UN Regulation No. 127 (Pedestrian safety)

Proposal for Supplement 2 to the 03 Series of Amendments to UN Regulation No. 127 (Pedestrian safety)

Submitted by the experts from France, Germany and the International Organization of Motor Vehicle Manufacturers *

Figure 12
Windscreen Test Area

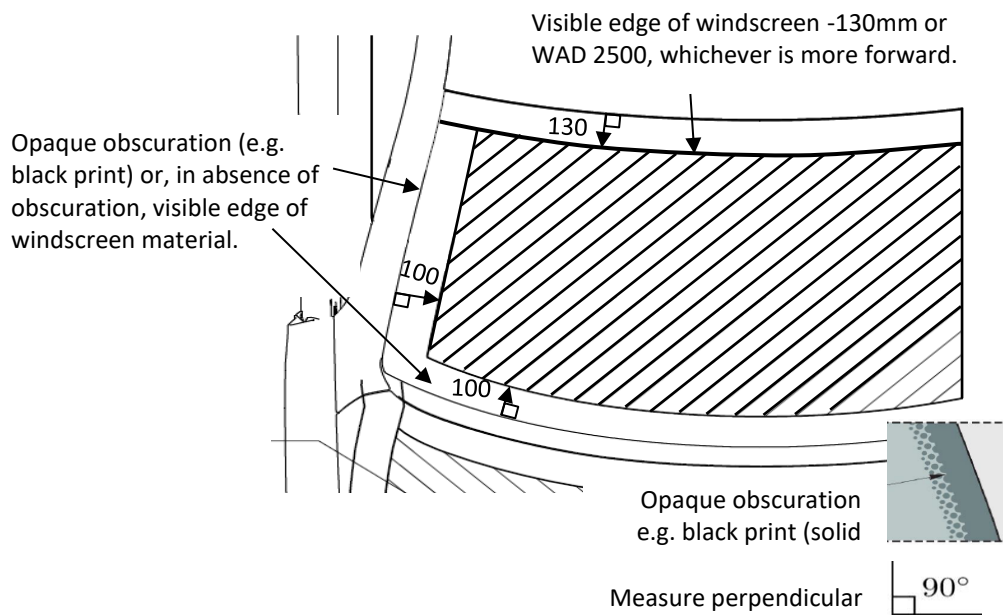
Paragraph 2.44., amend to read and insert Figures 12 and 13:

- "2.44. "Windscreen test area" is an area on the outer surface of the windscreen. It is bound (**see figure 12**):
- (a) In the front, by a line 100 mm rearward to the opaque obscuration of the windscreen. In case of absence of the opaque obscuration, the line is measured from the front visible edge of the windscreen material.
 - (b) In the rear, by a WAD 2,500 or a line 130 mm forward to the rear visible edge of the windscreen material, whichever is more forward at a given lateral position.
 - (c) At each side, by a line 100 mm inside the opaque obscuration of the windscreen. In case of absence of the opaque obscuration, the line is measured from the side visible edge of the windscreen material.

For (a) and (c): the distances of 100 mm are to be measured with a flexible tape held tautly along the outer surface of the vehicle at an angle of 90° to the tangent line to the opaque obscuration limit or in case of absence of the opaque obscuration, from the visible edge respectively.

For (b): the distances of 130 mm is to be measured with a flexible tape held tautly along the outer surface of the vehicle at an angle of 90° to the tangent line to the rear visible edge of the windscreen.

Figure 13
Upper Corner Definition with "Shortest Distance"

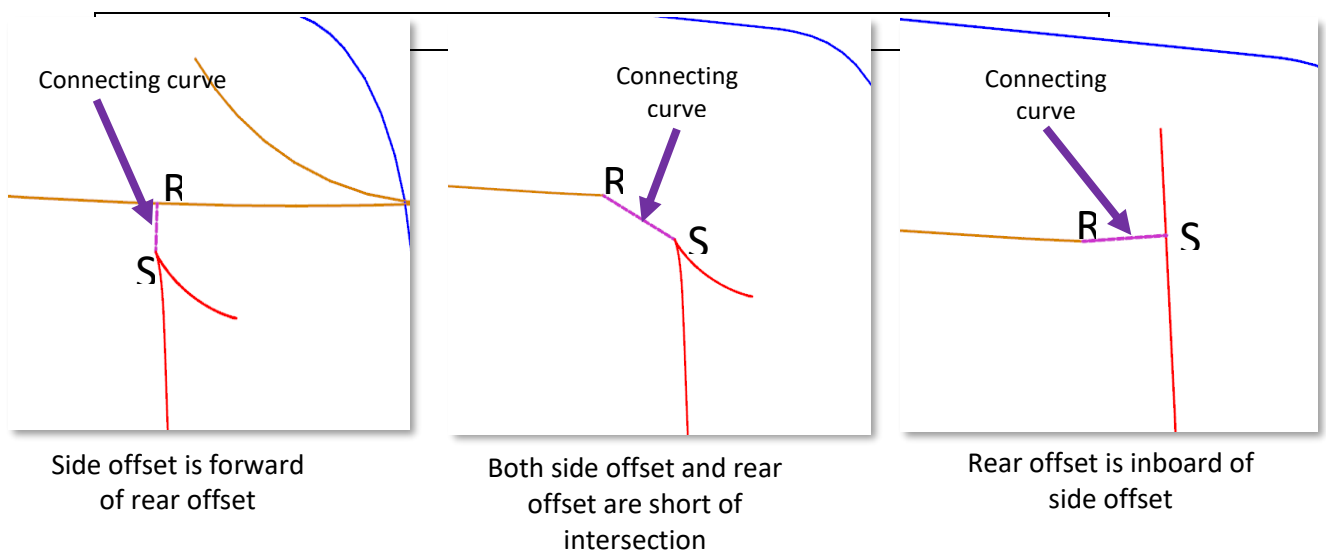
Depending on the geometry, in case there is no intersection between (b) and (c), resulting in an open test area, then the marking shall be modified using the shortest distance to close the open test area (see figure 13).

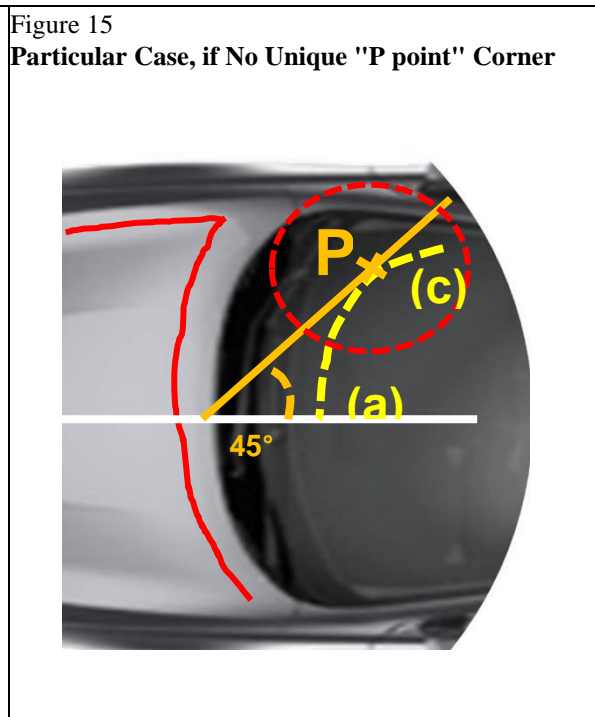
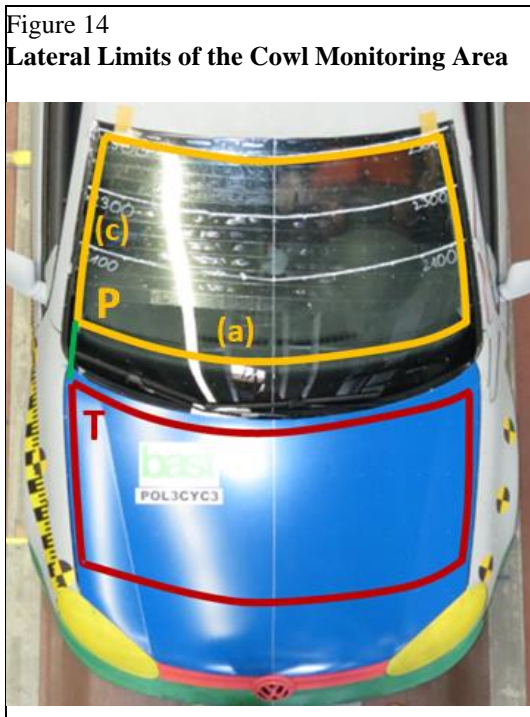
Paragraph 2.45., insert Figures 14 and 15 and amend to read:

At each side, the cowl monitoring area is bound by the TP line (see figure 14), where:

- (a) the "T point" is the rear corner of the bonnet top test area; and
- (b) the "P corner point" is the lower corner of the windscreen test area; using a flexible tape held tautly from point T to P.

If there is no unique "P point" where the lines defined in 2.44 (a) and (c) intersect, then the "P point" is defined by the first contact of a vertical plane intersecting the vertical longitudinal vehicle centre-plane at an angle of 45° with the (a)-(c) transition of the windscreen test area boundary, as shown in Figure 15.

Figure 16
Jerk Criterion Graph and Formula

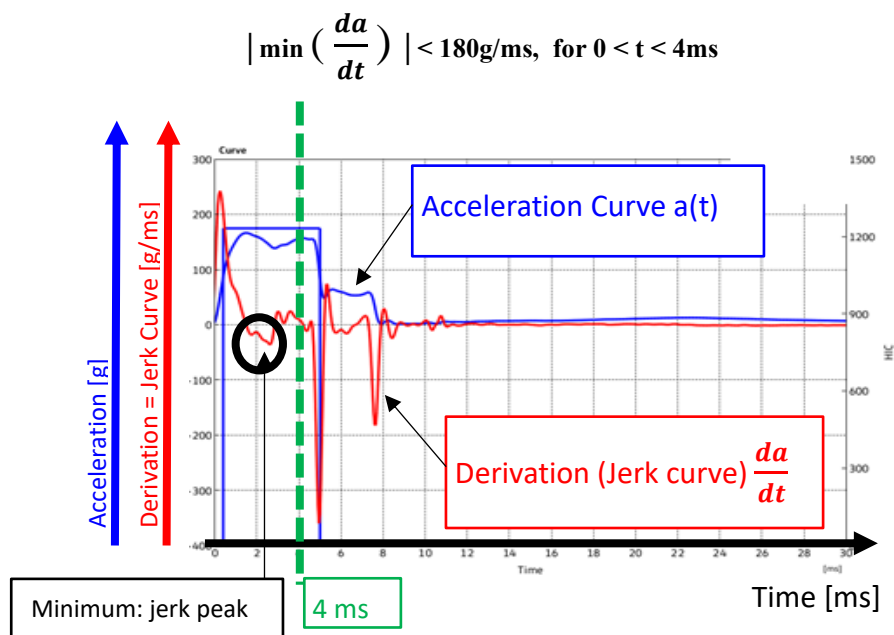
Paragraph 2.48., insert Figure 16 and amend to read:

- (a) The absolute value of the minimum value of the derivation of the headform acceleration versus time is ~~below~~ **less than** 180 g/ms ~~for~~ **within** the first 4 ms after the initial contact of the headform to the windscreen, **as shown in Figure 16** ; or
